Amendments to the Drawings:

REMARKS

In response to the Office Action mailed August 29, 2008, Applicant amended claims 1, 3, 4, 6, 7, 10, 12, 14, 25, and 26 and canceled claims 5, 13, 31. Claims 15-18 and 20-22 are withdrawn. Claims 1-4, 6-12, 14, 19, 23-30 are presented for examination.

Fig. 1

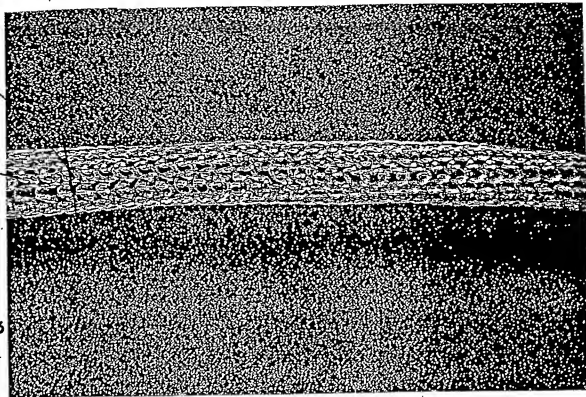
In Figs.1-3, photographs of subassemblies have been replaced with drawings of respective subassemblies.

Photographs
replaced
with
drawings

Fig. 3

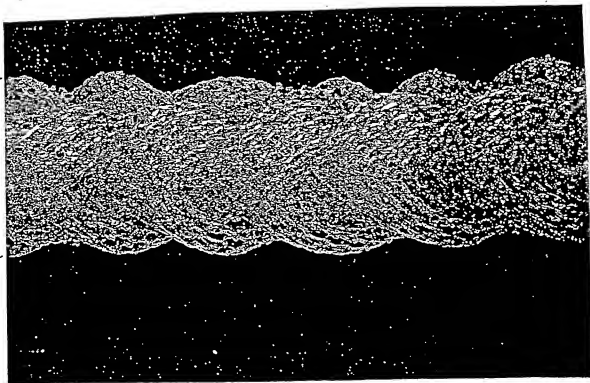
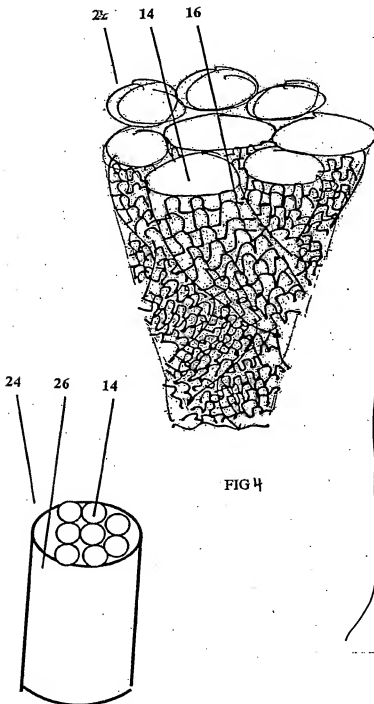
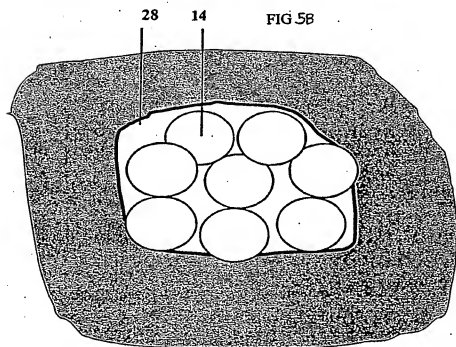
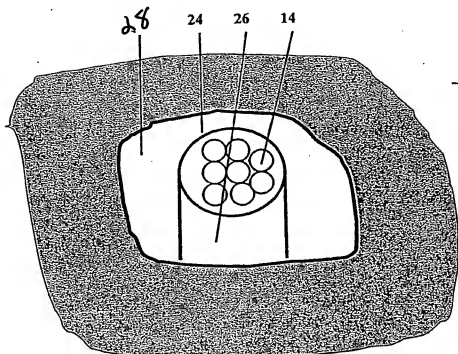
Photographs
replaced
with
drawings

FIG. 6C

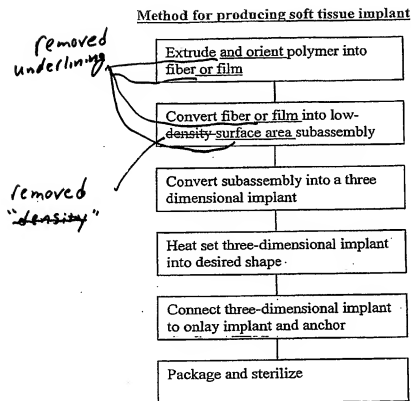
In Fig. 4, 5A-5B, 6C, the drawings have been replaced with drawings including lines, numbers, and letters of uniform thickness and improved legends.

Drawings
replaced with
drawings
including lines,
numbers, and
letters of
uniform
thickness and
improved
legends.

Fig. 9D

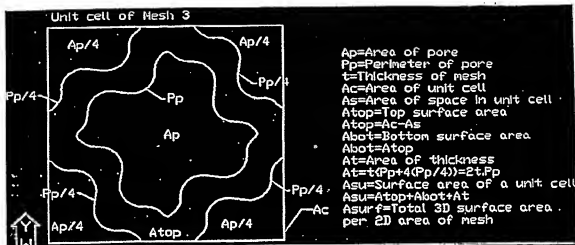
In Fig. 9D, the drawing has been replaced with drawings including lines, numbers, and letters of uniform thickness and the legend has improved. The figure has been amended such that all rows of the table are on the same page and blank rows have been removed.

→ FIG. 9D put on one page.

FIG. 9D
 put on
 one
 page.

Delete
 empty
 rows
